RE: Amendment Application for the Hotazel Solar Facility

ABO Wind Hotazel PV (Pty) Ltd wishes to apply for an amendment to the authorised Hotazel Solar facility (EIA Ref No: 14/12/16/3/3/2/1086), located near Hotazel in the Northern Cape. The Environmental Authorisation (EA) Amendment Application proposes a change to the layout of the facility. Cape EAPrac has therefore requested a comparative assessment and comments from 3Foxes Biodiversity Solutions to assess the proposed changes in the context of the former Avifaunal Impact Assessment and to determine any impacts resulting from the proposed amendments. The motivation for and nature of the intended amendment include the following:

Figure 2. Avifaunal sensitivity map of the study area, showing the approved and the proposed amended footprint of the PV field.

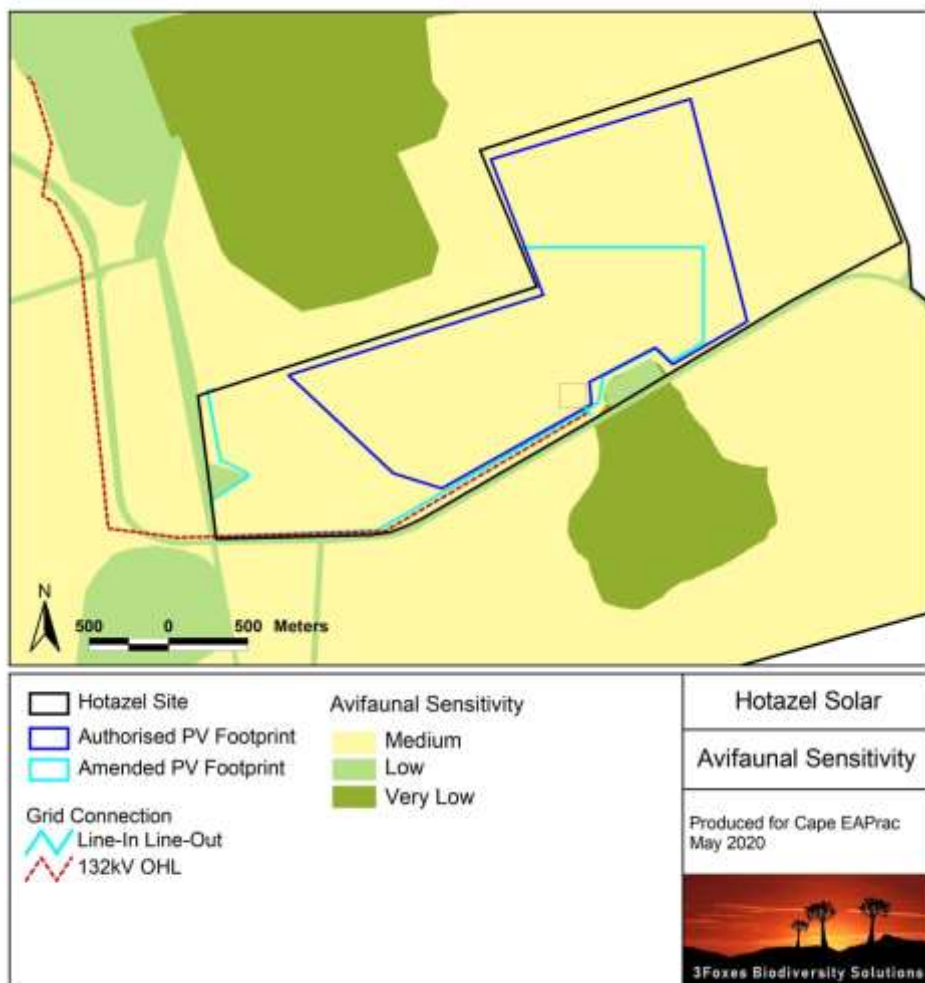
The approved and the proposed amended PV footprint areas in relation to the avifaunal sensitivity of the site, are illustrated below in Figure 2. The area into which the new PV field would expand is considered medium avifaunal sensitivity, which is the same as that within the authorised footprint. There is however an increase in the density of woody plant vegetation as one moves towards the western margin of the site. The proposed amended footprint would therefore include some of these areas. The differences in tree density are associated with concomitant shifts in the avifaunal community across the site. The original EIA study found that “Some species showed rather clear preferences for parts of the study area. Northern Black Korhaan *Afrotis afraoides* was found exclusively in the eastern half of the site, which is less dense with

The original study found that construction-phase impacts on avifauna would be Medium-Low after mitigation and that operational impacts would be Low after mitigation. The westward shift in the PV field would not have significant additional implications. Therefore, the above impacts will remain the same for the amended layout of the facility.
